**DATE:** 03.04.2015  
**TO:** ProTrak  
**FROM:** Bill McDow  
Transportation Planning

■ **WRIGHTSVILLE MANOR EVENTS CENTER [TRC Plan Review]**

↻ Initial Review Note ↻

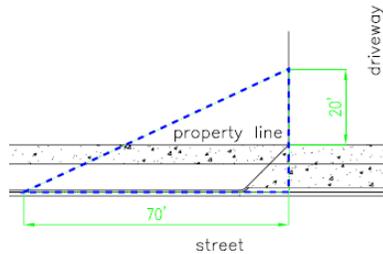
5. A second option for the HC parking would be to make the first spaces in the first row become HC spaces, then the sidewalk that crosses this drive aisle could be removed and extra parking spaces could be added on the site, ( see sketch attached).
